# Access Compliance Report

## Public Rights-of-Way

### (Curb Ramps)

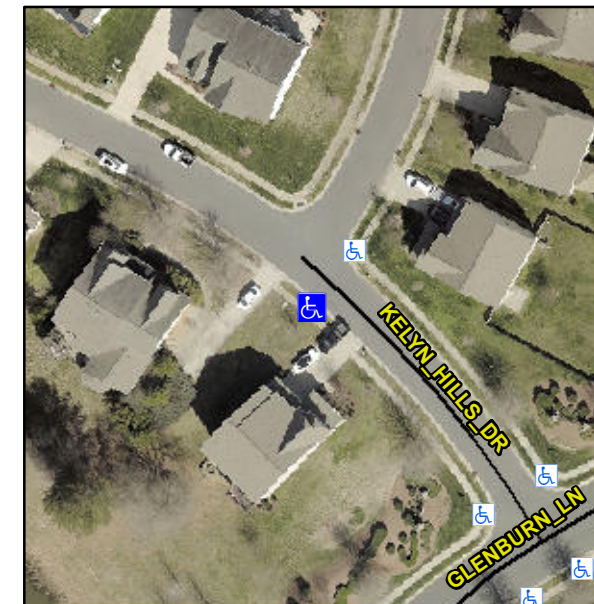
Intersection ID: N/A	Main Street: KELYN_HILLS_DR	Cross Street: KINLEY_COMMONS_LN	Location: SW
ADA ID: 263C1B745C41	Ramp Type: Perp	Initial Pass/Fail: Fail	Overall Compliance: No
Severity Score: 8.75			
Codes/Mitigation Info/Possible Solution		Field Measurements/Component Compliance

**Not Found, R304.5.1**

Compliance	Description	Data	Compliance	Description	Data
N/A	Ramp Length (in)	48.0	Yes	Ramp Slope (%)	6.0
No	Ramp Width (in)	43.0	Yes	Ramp XSlope (%)	0.3
N/A	Flare Type LT	N/A	N/A	Flare Type RT	N/A
N/A	Flare Slope LT (%)	N/A	N/A	Flare Slope RT (%)	N/A
N/A	Flare Traversable LT?	N/A	N/A	Flare Traversable RT?	N/A
N/A	Landing Length (in)	N/A	N/A	DWS Provided?	N/A
N/A	Landing Width (in)	N/A	N/A	DWS Contrast?	N/A
N/A	Landing Slope (%)	N/A	N/A	DWS Length (in)	N/A
N/A	Landing X Slope (%)	N/A	N/A	DWS Full Width?	N/A
N/A	Landing Curb? (Y/N)	N/A	N/A	DWS Offset (in)	N/A
N/A	Shared Landing?	N/A			
N/A	Gutter Ponding?	N/A	N/A	Gutter Slope (%)	N/A
N/A	Gutter Lip Ht (in)	N/A	N/A	Gutter X Slope (%)	N/A
N/A	Painted X Walk1?	No	N/A	Painted X Walk2?	N/A
	X Walk 1 Direction	To NE		X Walk 2 Direction	N/A
N/A	X Walk 1 Width (in)	N/A	N/A	X Walk 2 Width (in)	N/A
	X Walk 1 Slope (%)	3.2		X Walk 2 Slope (%)	N/A
	X Walk 1 X Slope (%)	1.0		X Walk 2 X Slope (%)	N/A

**Remove & Replace Entire Ramp.**
